SECTION 009113 – ADDENDUM TWO

- A. Project Name: 22034.02 Meridian High School Additions, Renovations and Ballfield Rebid
- B. Owner: Meridian Public School District, 1019 25th Avenue, Meridian, MS 38391
- C. Architect: Dale | Bailey, an Association, One Jackson Place, Suite 250, 188 East Capitol Street, Jackson, MS 39201-2100
- D. Architect Project Number: 22034.02
- E. Date of Addendum Two: 12 January 2024

1 Site Layout Diagram
1" = 100'-0"

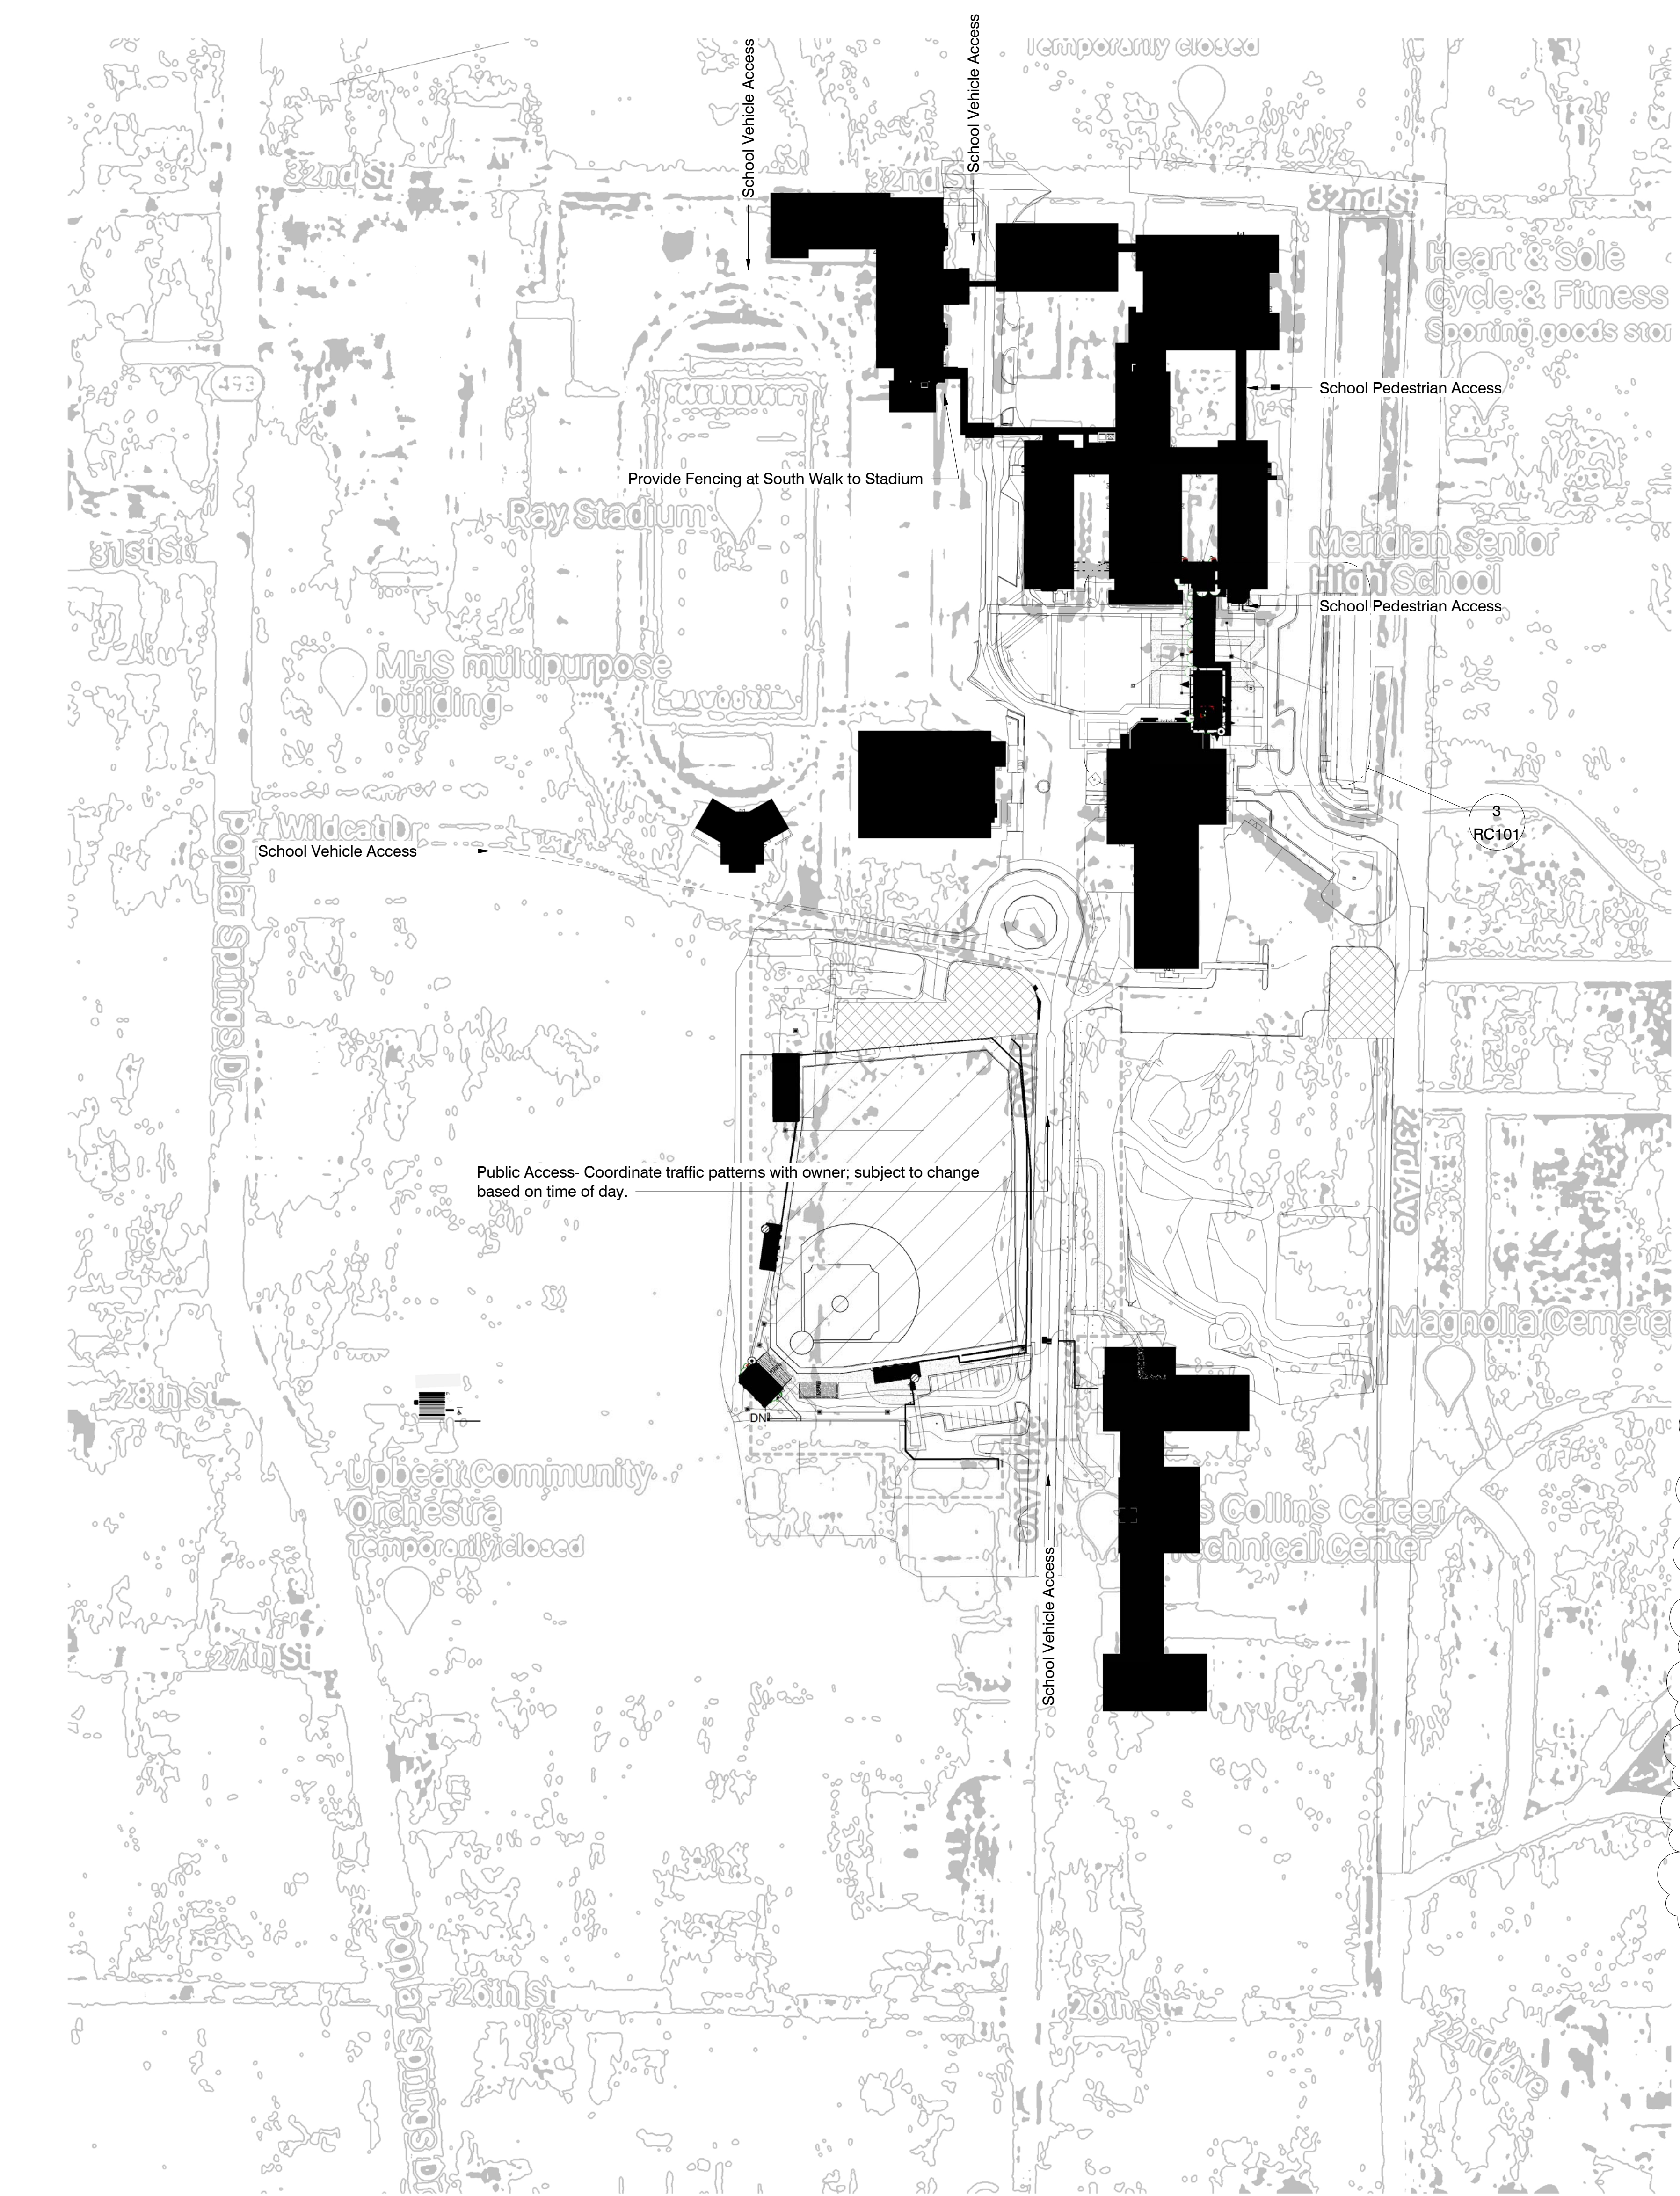
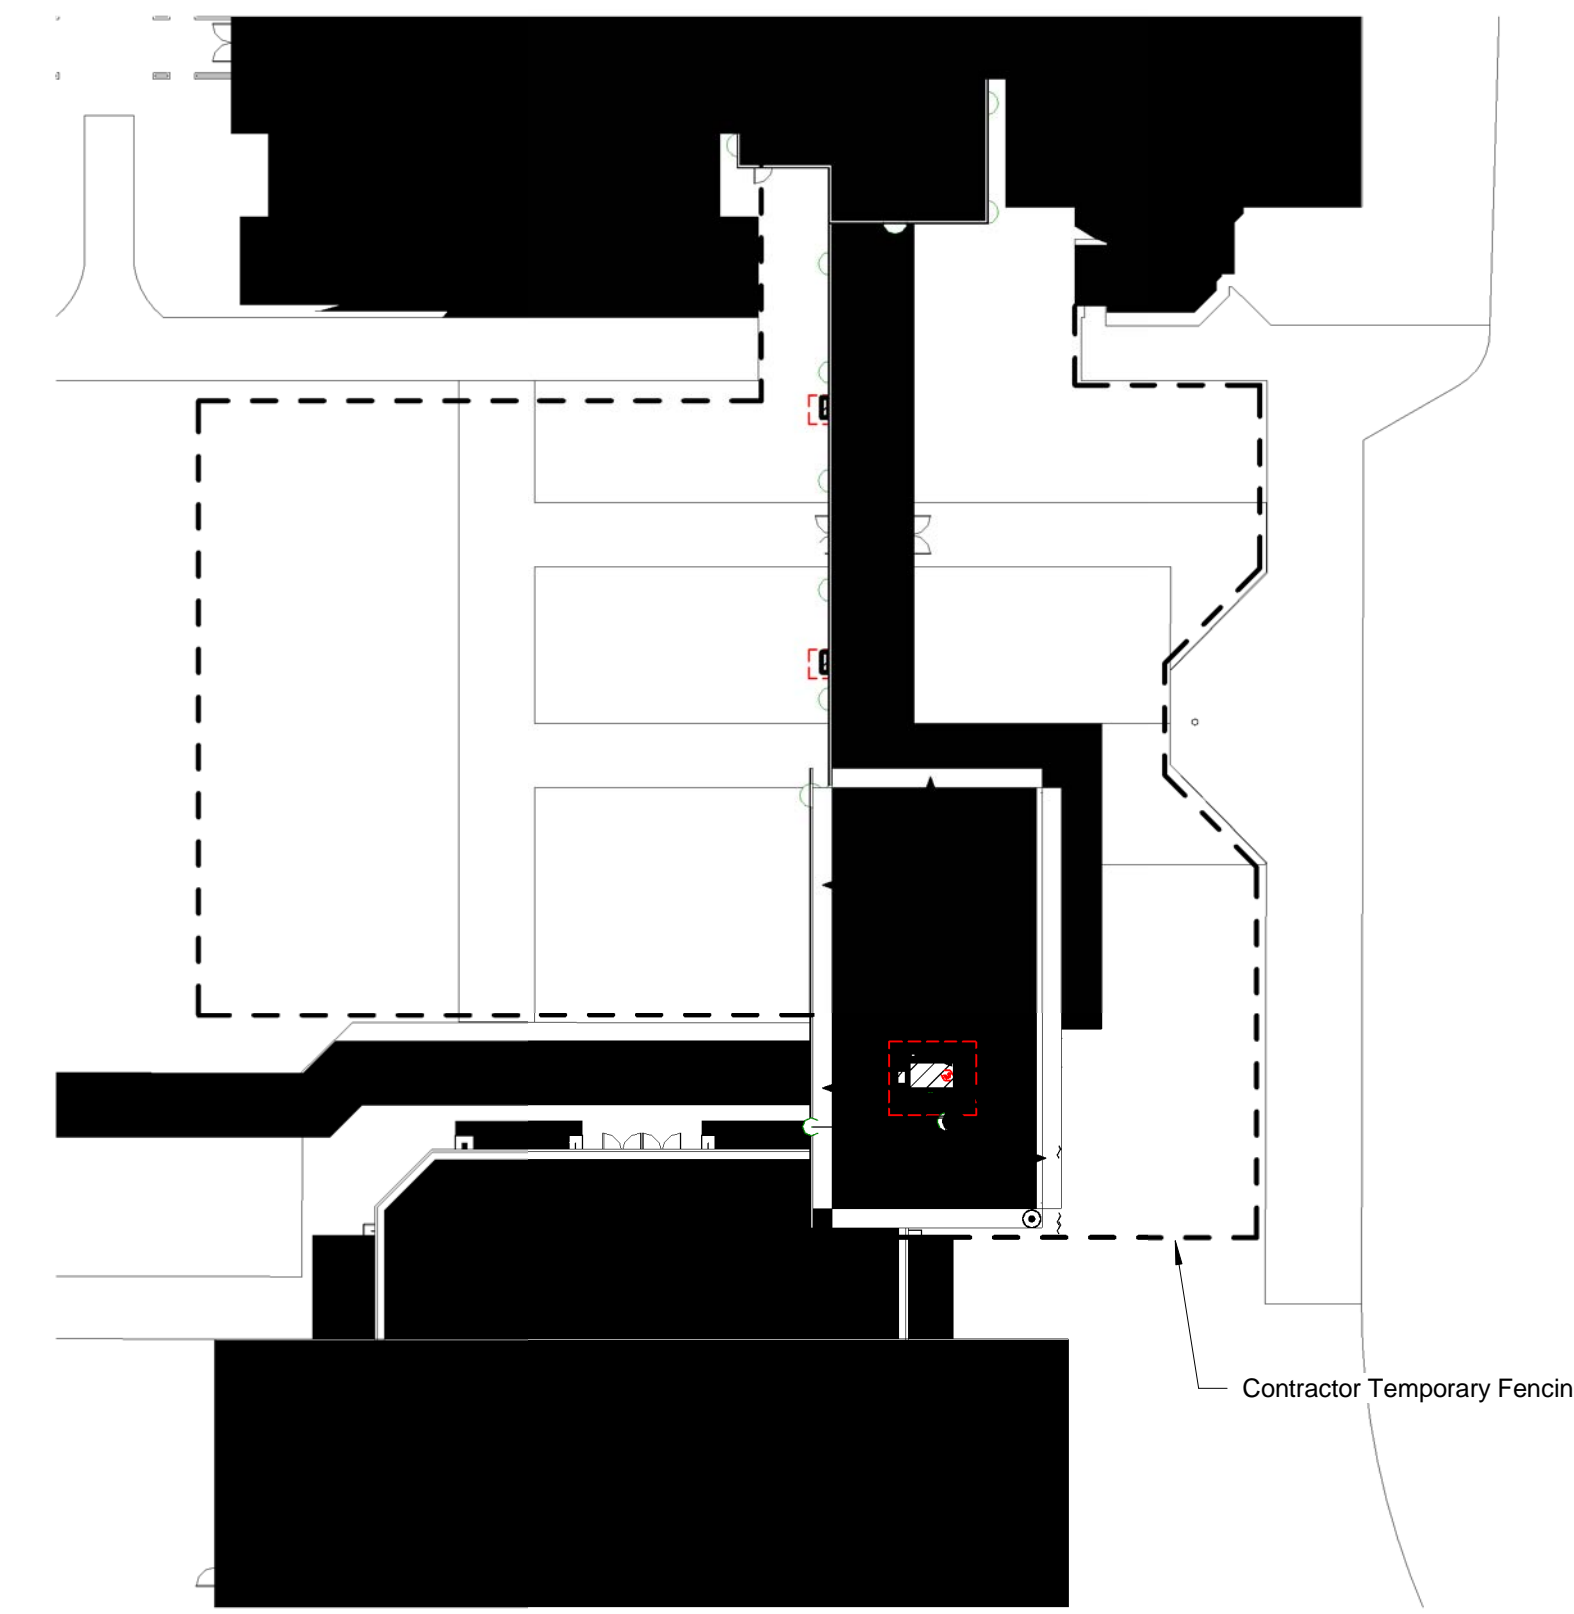
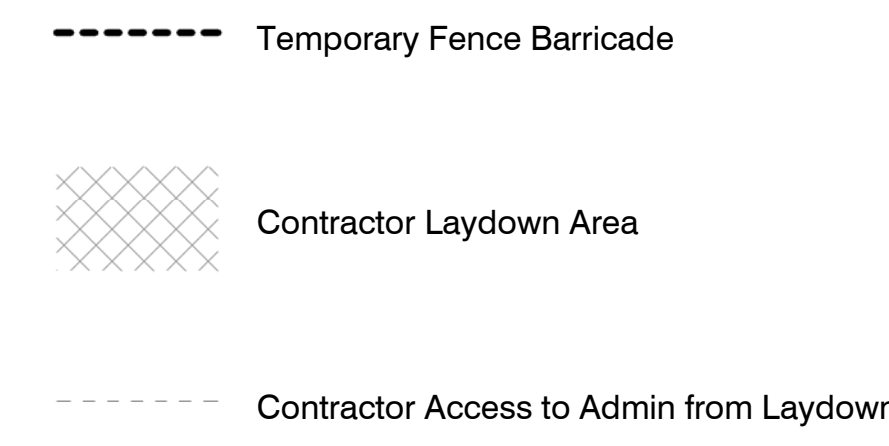
- E. QUESTION: Is a temporary fence barrier required for construction.

- A. Sheet AS101 – Architectural Site Layout (Revised). Added guard shack location and awning brick detail.
- B. Sheet A-491 – Restroom Details (Revised). Added quantities to toilet accessories..
- C. Sheet RC101 – Site Layout & Access (Revised). Corrected print issue and added clear temporary fencing layout for project.
- D. Sheet E-004A – Electrical Renovation Site Plan (Revised). Added power for modular building.
- E. Sheet E-201B – Overall Power Plan (Revised). Deleted power for modular building.

ANSWER: Yes, see updated RC101.

Meridian High Addition
E-004a
 ELECTRICAL RENOVATION
 SITE PLAN

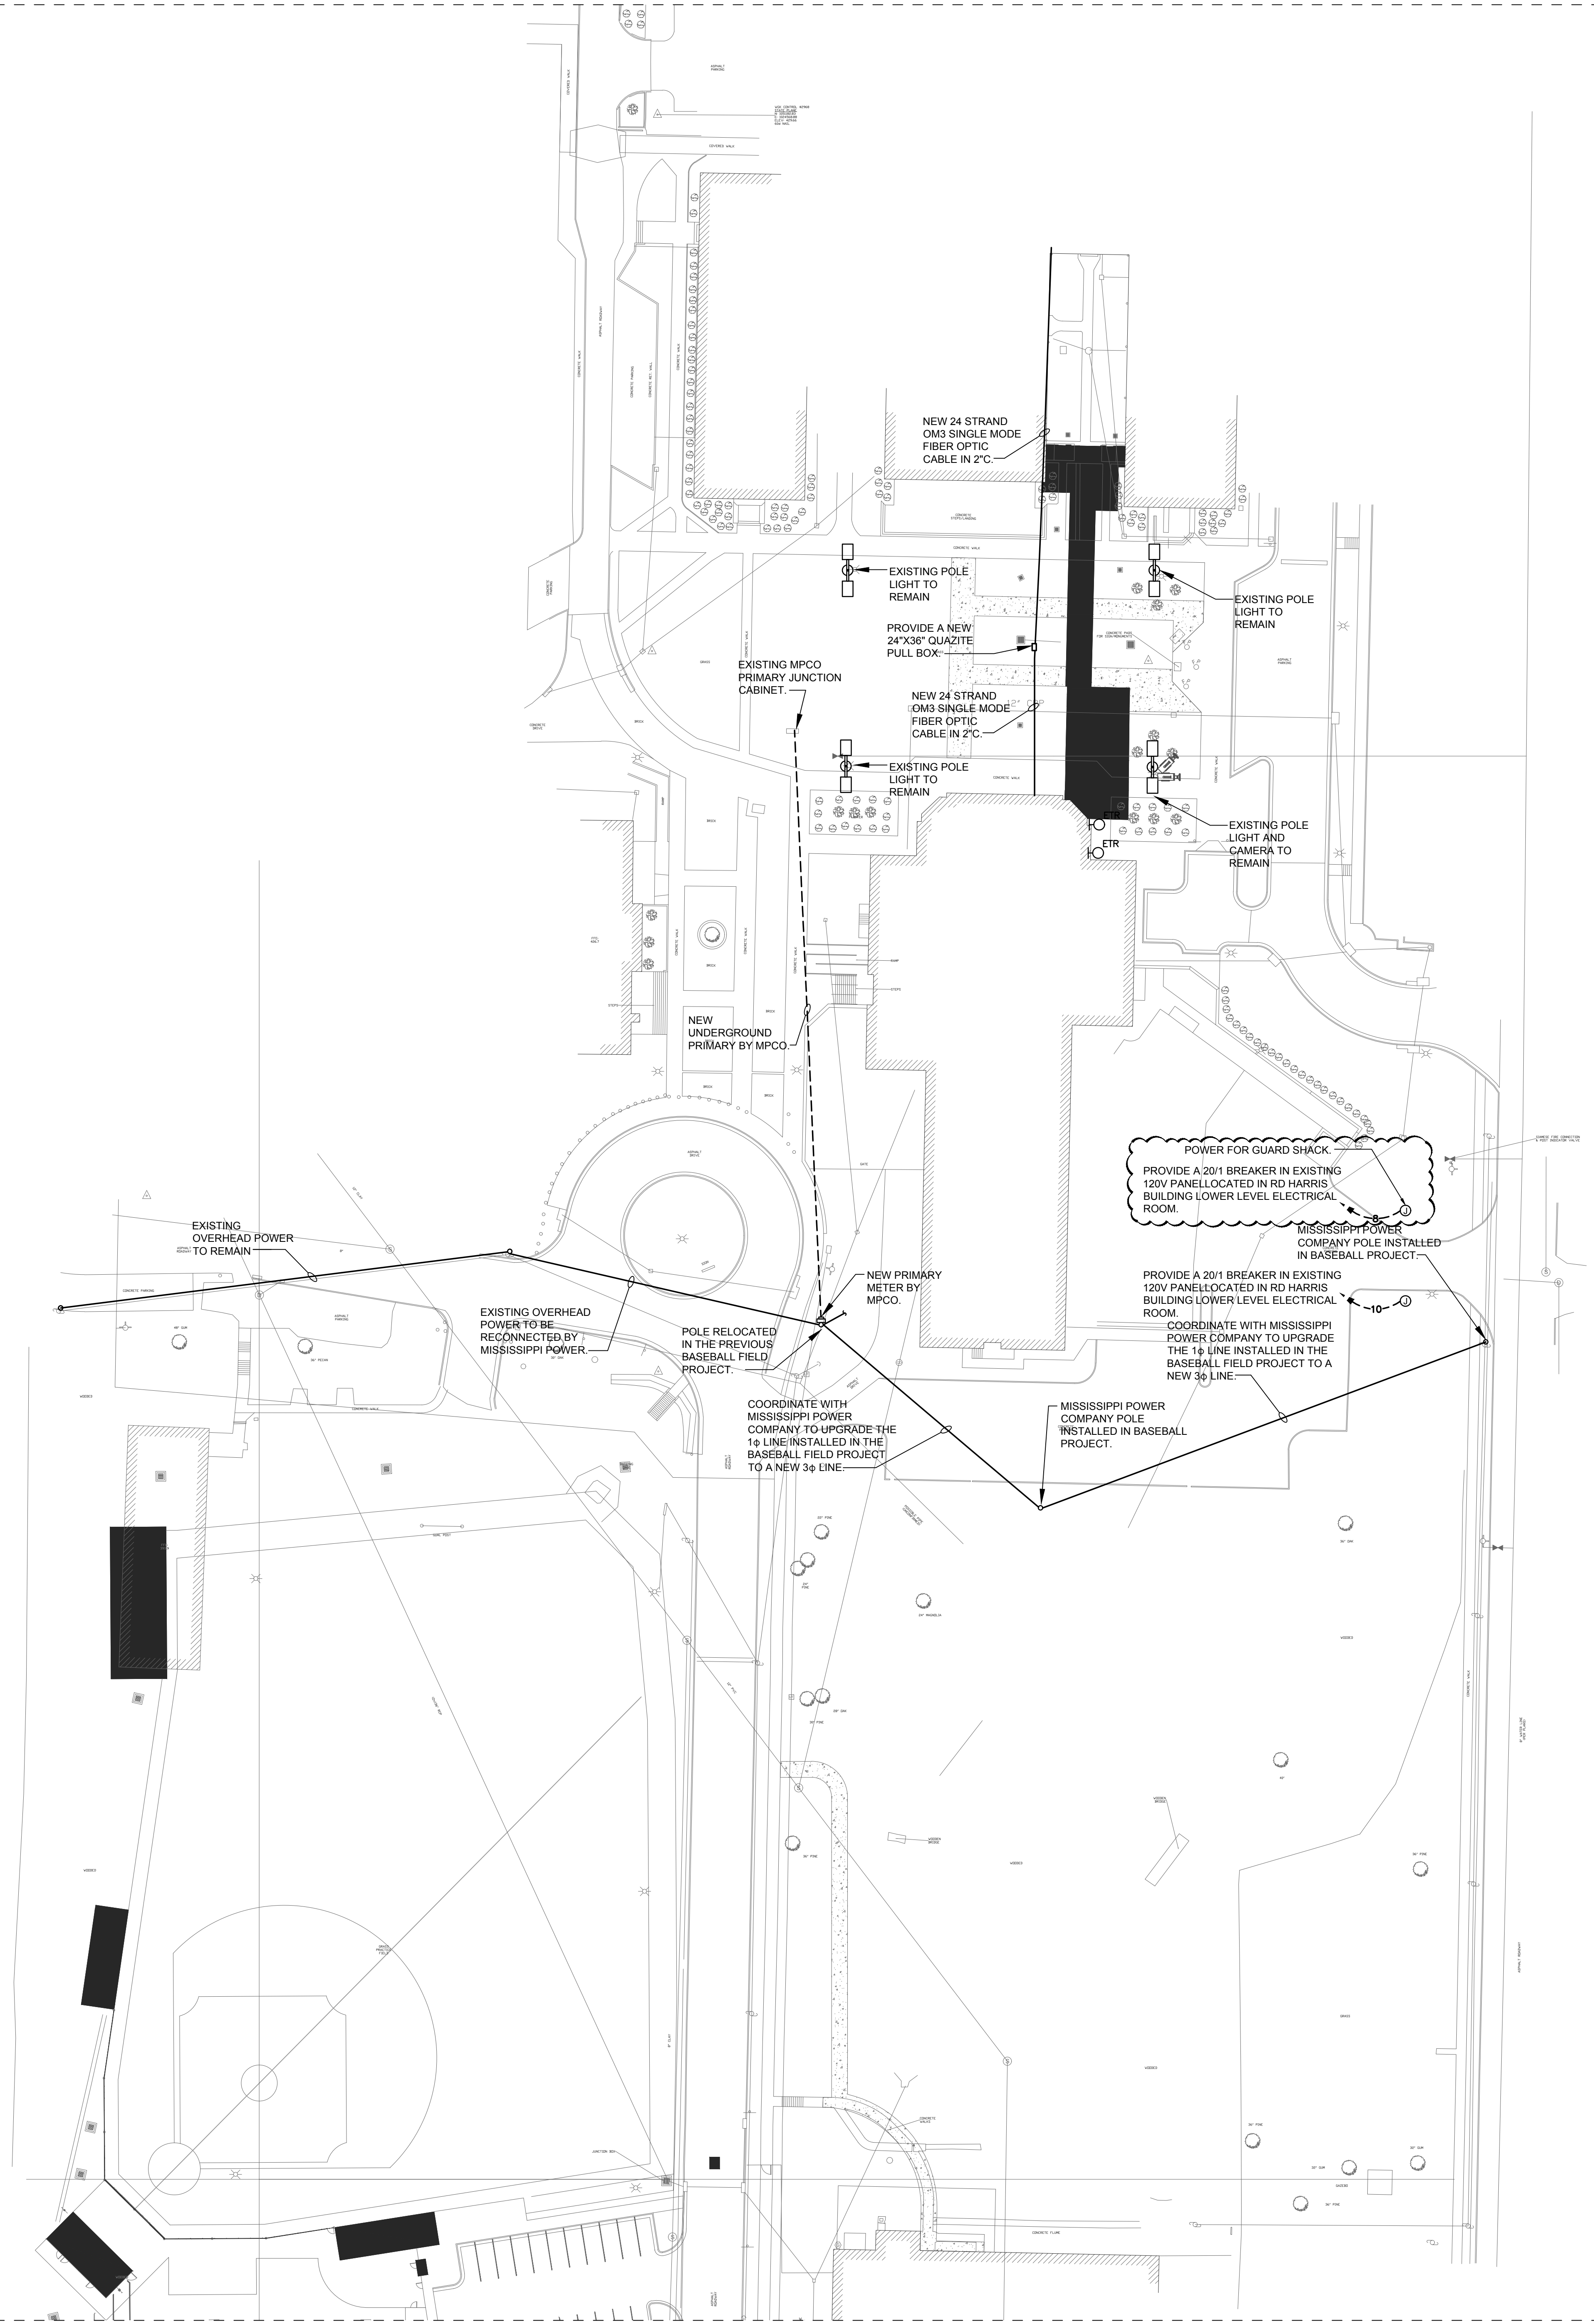
- I. QUESTION: E 004a has a note to Coordinate with Mississippi Power upgrading existing service lines. Is this cost going to be covered by the Owner.

ANSWER: See added allowance to cover this cost.
